April 16, 2011

**Request for Minister's Review of Director's Decision that an
Individual Environmental Assessment is Not Required
for the
Proposed Bala Falls Hydro-electric Generating Station**

Figure 1 – Existing and Proposed Flow Over North and South Falls
 (values from the environmental screening report, Figure 2.4 and Figure 6.1)

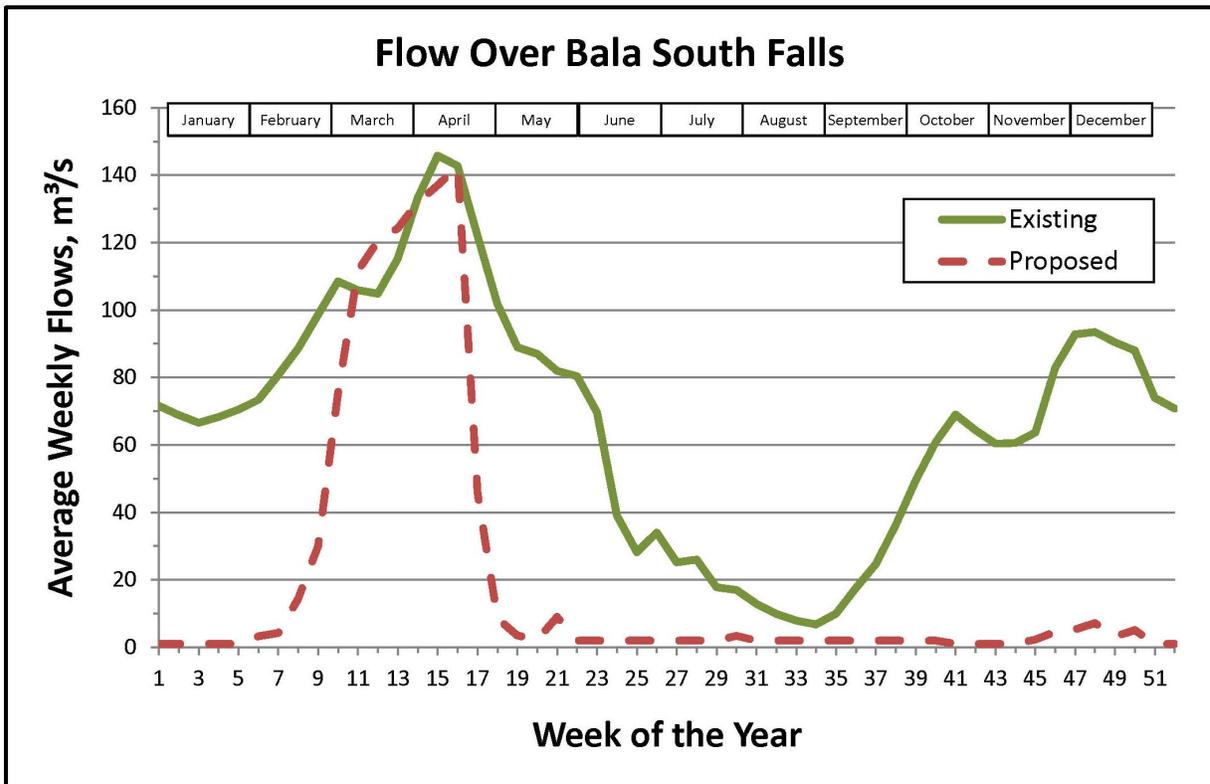
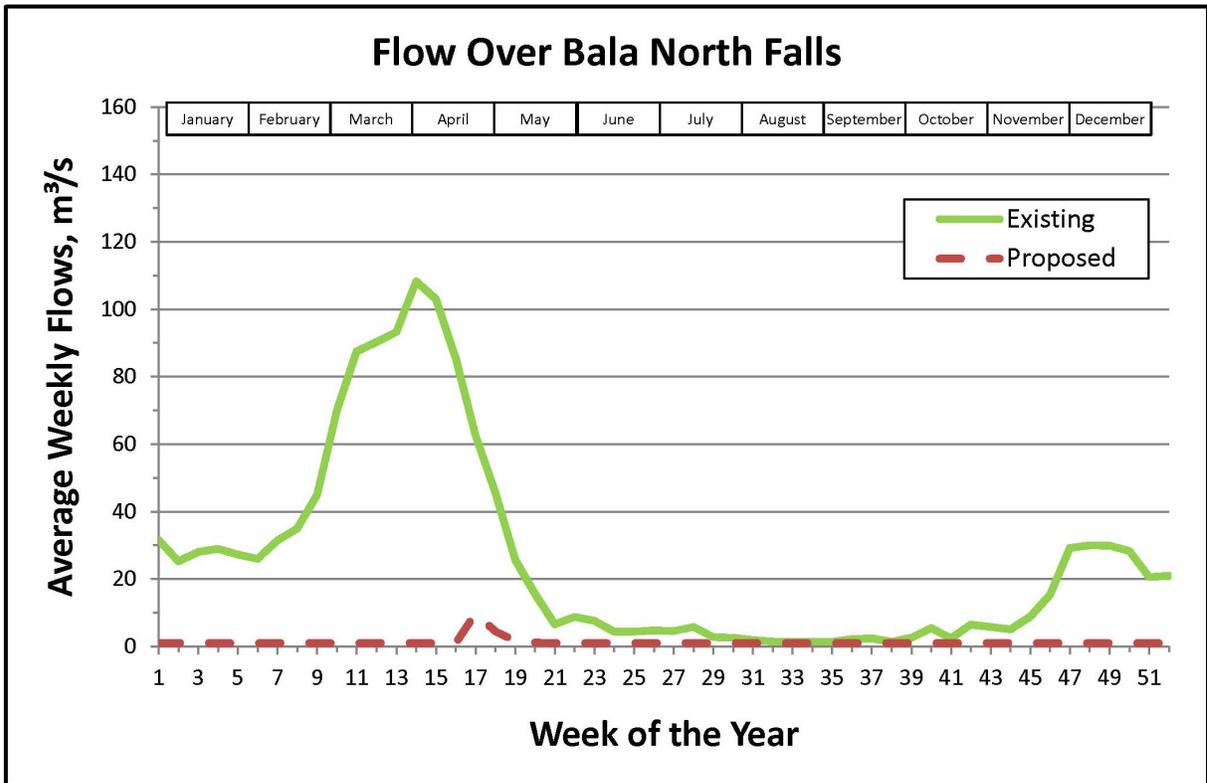
Issue	Director's Response	Unaddressed Concern
Scenic flow	<p>Director notes “<i>The existing MRWMP stipulates that a summer minimum of 1 m³/s be released at each of the two Dams. The ESR documents proposed flows of 1 m³/s over the North and South Dam throughout the year with an increase to 2 m³/s proposed at the South Dam during the summer tourist (viewing) period.</i>”</p>	<p>This statement is not correct. The existing Muskoka River Water Management Plan (“MRWMP”), Table 5.2 <i>Existing Flow and Water Level Operating Constraints for Muskoka River Dams</i>, row “Bala North and South Dams” notes “<u>Minimum outflow of 3.0 m³/s from each dam</u> is to be maintained by leakage or log removal to maintain downstream water quality”.</p> <p>Second, any reduction (such as to the 1 m³/s or 2 m³/s as proposed), or even to allow only 3 m³/s over the falls throughout the year has no justification from a community and tourist viewpoint, despite attempts at input by the proponent’s own flow distribution committee (see below).</p> <p>Third, the tourism economy of Bala is important year-round, for example:</p> <ul style="list-style-type: none"> • As noted in the District Municipality of Muskoka’s Official Plan, dated October 15, 2008, goal C.23 is “<i>Efforts to make commercial tourism year round will be supported.</i>” • On October 21, 2008 the Township of Muskoka Lakes passed Resolution Number C-14-21/10/08 which included a requirement that “the environmental screening process takes into consideration the potential impact that the proposed construction may have on Bala’s economy, including its important winter economy ...”. • The MRWMP (Section 6.1.2) notes “Recreational season has expanded beyond the traditional ‘July/August’ summer period to span from early May to late October – more recreational users for a longer time period.” <p>However, as shown in Figure 1 below, the:</p> <ul style="list-style-type: none"> • Flow over the north Bala Falls would be reduced from a wide variety of flows to a consistent 1 m³/s (except for perhaps a few days in April). That is, there would be nothing to look at year-round. While this may be something safe to splash in in August, it would not draw people to Bala. • Flow over the south Bala Falls would be also be reduced to basically nothing year-round, except for March and April. <p>If you ask people why they repeatedly visit the falls, you’ll find it is to see what they look like “today”. The variability is as important as the flow. The proponent would have learned this if they would interview residents, businesses, and tourists.</p> <p>Finally, we note that Mr. Steve Taylor of the MNR told the Flow Distribution Committee on October 13, 2010 that the summer flows over the north falls are typically 4 m³/s, and over the south falls are typically 7 m³/s. Two items of note:</p> <ul style="list-style-type: none"> • This means that the trickle of 1 m³/s or 2 m³/s of scenic flow offered by the

Issue	Director's Response	Unaddressed Concern
		<p>proponent would be a significant reduction to the existing summer flows, and a major reduction for the remainder of the year.</p> <ul style="list-style-type: none"> The proponent's statements of the summer flow being maintained throughout the year are wrong and misleading: Firstly, the summer flow over the north falls is actually greater than they state. Second, the flow over the south falls is greater all the time and they neglect to mention this important point. <p>That is, tourism depends on something to see, and conformance to the MRWMP does not provide for this.</p> <p>Finally, the Electricity Guide requires "an assessment of the significance of any net effects or concerns", and as regards to the tourism impact, this has not been provided for the proposed 94% reduction in scenic flow over the falls.</p>
	<p>Director notes "<i>The ESR also states that the minimum flows required to operate the Project is 20 m³/s. Any incoming flows of 20 m³/s or less (which may occur during the summer season) will be distributed entirely over the two Dams and the Project will shutdown until the flow increases to operating conditions, i.e. water flows over 20 m³/s.</i>"</p>	<p>This is not correct, the December 16, 2010 agreement between the proponent and Ontario Power Generation (OPG) states that the proponent would be <u>required to cycle the operation</u> of the proposed generating station when there is less than 26 m³/s of flow.</p> <p>Therefore, the Director's statement about the flows of less than 20 m³/s being distributed over the two dams would be incorrect.</p>

Figure 2 – Length of Publically-accessible Shoreline Which Would Become Too Dangerous For Access (is 160 m / 526') (also showing proposed upstream safety boom is concave)

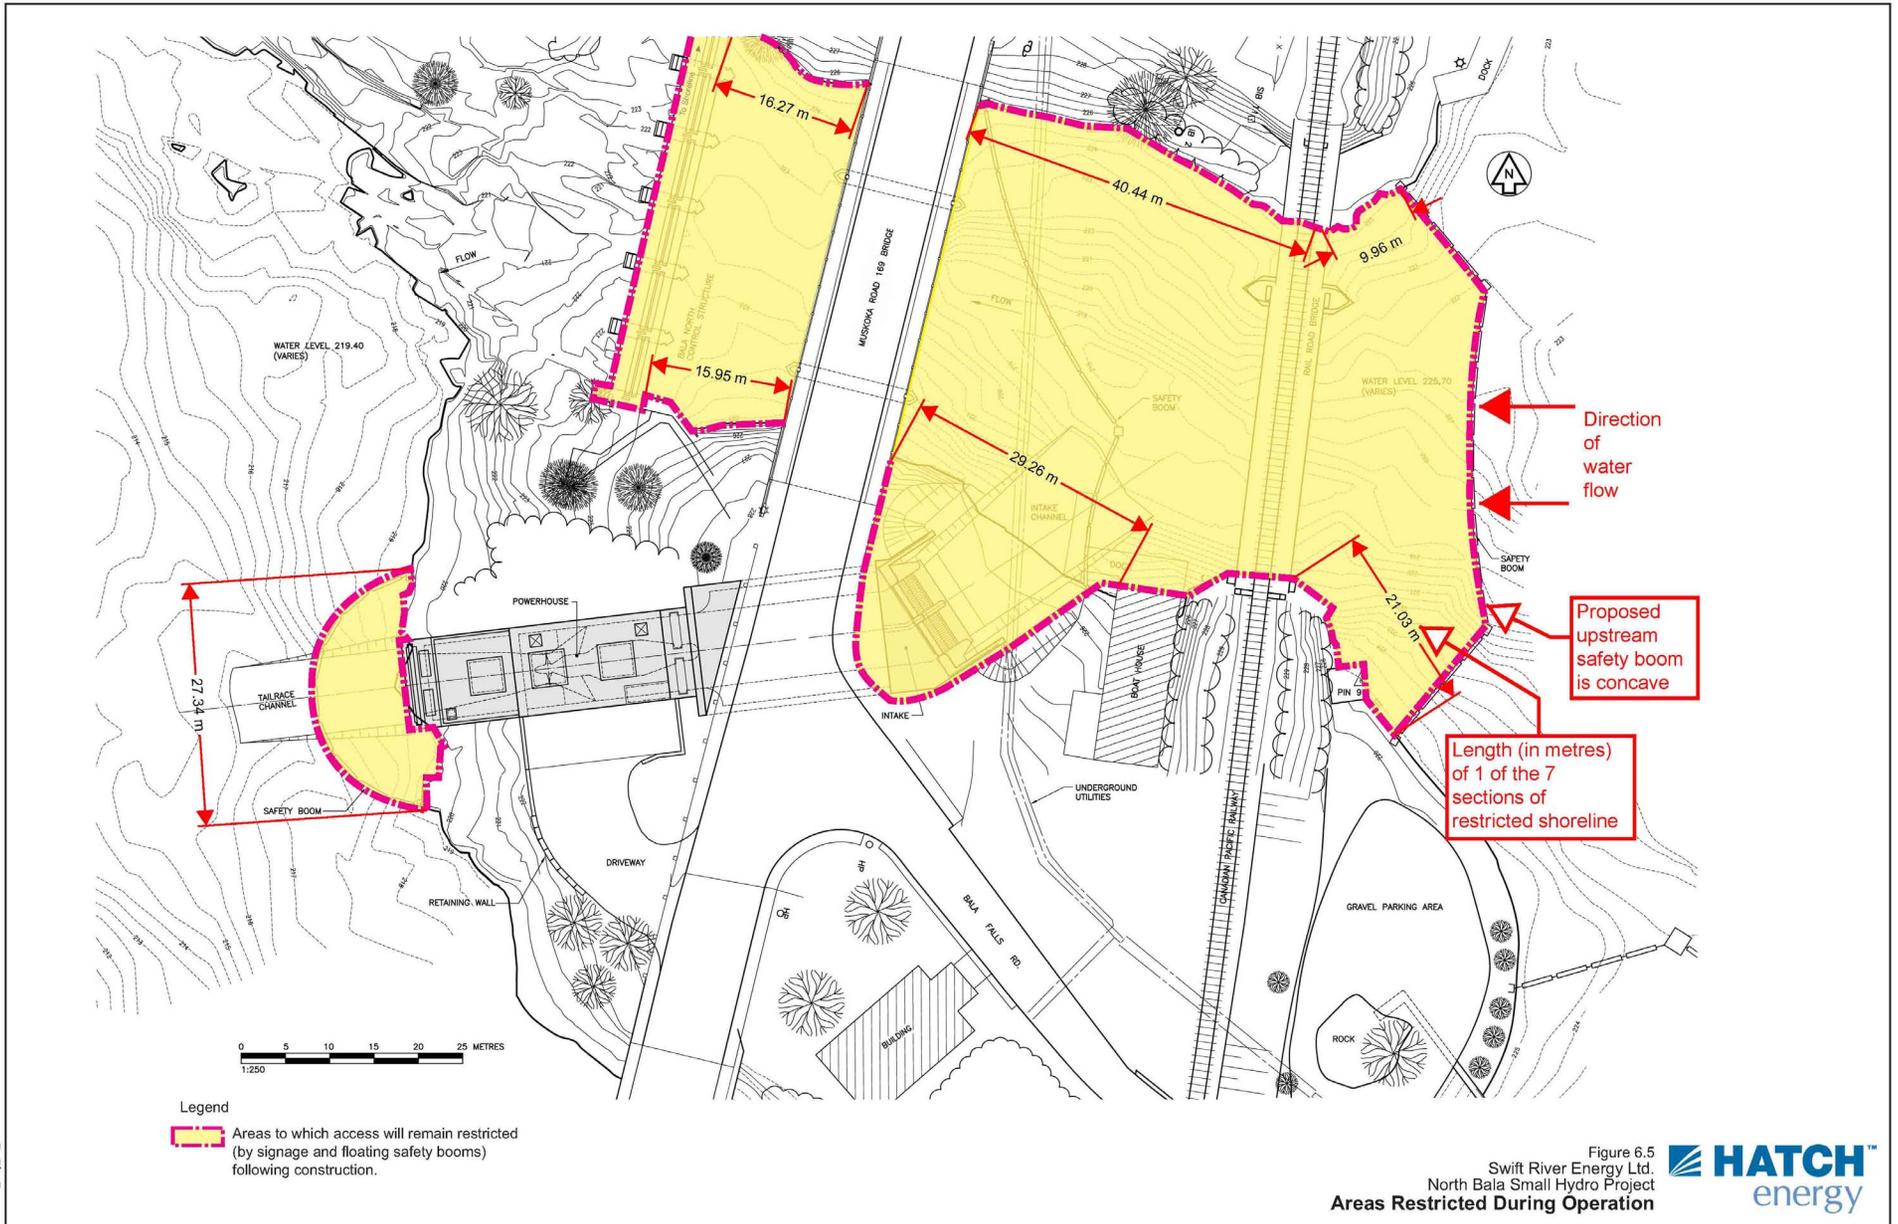
Shoreline access	Director notes that only the shoreline adjacent to Purk's Place and at the tailrace of the proposed project would be restricted.	<p>This is not true. As shown in Figure 2 below, the shoreline between the Don's Bakery parking lot and the town docks (that is, the north side of the north channel) would also be too dangerous for public access.</p> <p>In total, and according to the proponent's own scale drawing, and reproduced in Figure 2 (dimensions added), <u>over 525' of currently-accessible Muskoka shoreline would become too dangerous to use.</u> In addition:</p> <ul style="list-style-type: none"> • The proponent has not shown how the 120' section of popular (for fishing) shoreline between the proposed project and the south channel would be accessed, as their 20'-high driveway retaining wall would prevent this. • And the water access they would allow to the north of this would literally be in the shadow of a 20'-high poured-concrete structure with noisy exhaust fans, and directly adjacent to the dangerously turbulent water exiting their

Upstream safety boom	Of the upstream safety boom location, the Director notes that Transport Canada has " <i>reviewed the Project documentation and confirmed to SREL that the proposed intake boom location, upstream of the Canadian Pacific rail bridge, is reasonably placed</i> ".	<p>This is not following industry best practices. Documents from the Canadian Dam Association (the Spring 2009 issue of their <i>Bulletin</i>, as well as <i>Guidelines for Public Safety Around Dams</i>) and the Ministry of Natural Resources (draft of <i>Technical Guidelines and Requirements for Approval Under The Lakes & Rivers Improvement Act, Volume Four – Public Safety Around Dams</i>) discuss the design and orientation of safety booms.</p> <p>A major focus of safety boom design is <u>whether the location and orientation facilitates self-rescue</u> of boats being pushed into the safety boom by the current – as this is obviously preferable to depending on another party being notified, available, and able to assist.</p> <p>The proponent has proposed <u>a concave-shaped upstream safety boom, this dangerous design would hold one's boat in the middle</u> of the north channel.</p> <p>For undisclosed reasons, Transport Canada is not requiring the safer "inverted-V" design, therefore placing the public, as well as those tasked with rescue responsibilities to increased danger.</p> <p>While the safety boom for the south dam currently uses a concave design:</p> <ul style="list-style-type: none"> • The proposed safety boom would be more than <u>250' closer</u> to where the boating takes place. • The 45'-deep water intake for the proposed generating station would be far more dangerous than a dam. <p>This repeated compromising of safety is a problem which has not been addressed.</p>
